Subject: NRC Requests for Additional Information (RAI) Related to the Audit of the Economic Simplified Boiling Water Reactor (ESBWR) Steam Dryer Design Methodology Supporting Chapter 3 of the ESBWR Design Control Document – Draft Response for RAI 3.9-286

Draft Response for RAI 3.9-286

NRC RAI 3.9-286

Figure 1: Double sided fillet welded T-joint with nomenclature for analyses.

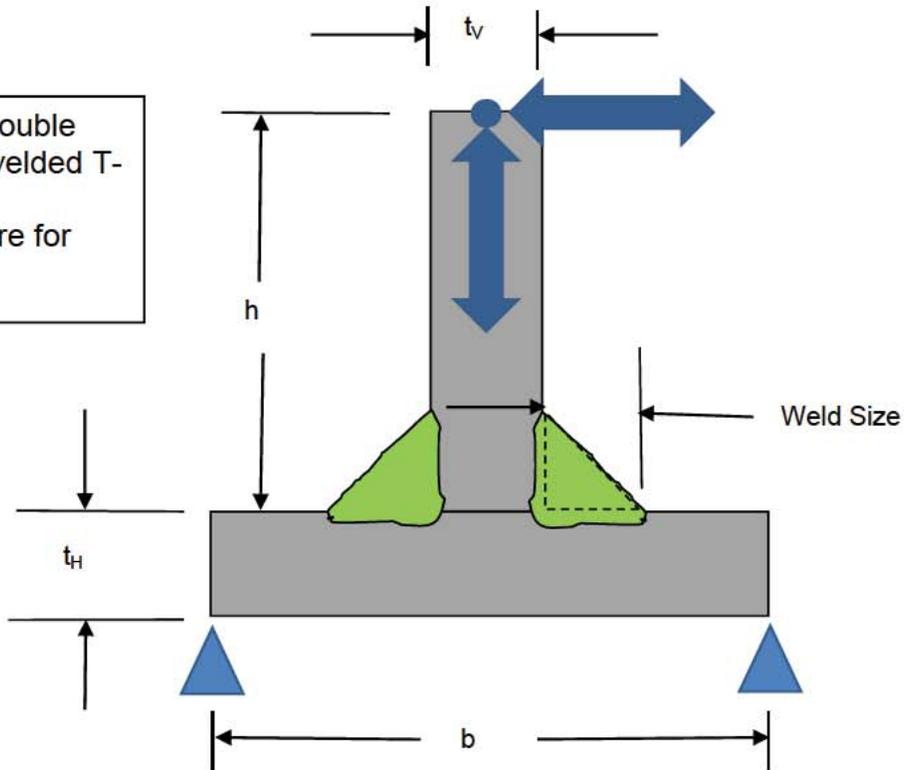
To provide information to conclude that method (2) provides a more conservative result than method (3) the NRC Staff requested GEH to perform additional analyses. A typical double sided fillet welded T-joint used for ESBWR steam dryer design is shown in figure 1 (same as RAI 3.9-285), an ASME BPV Code Section III NG-3352 Type V weld joint.
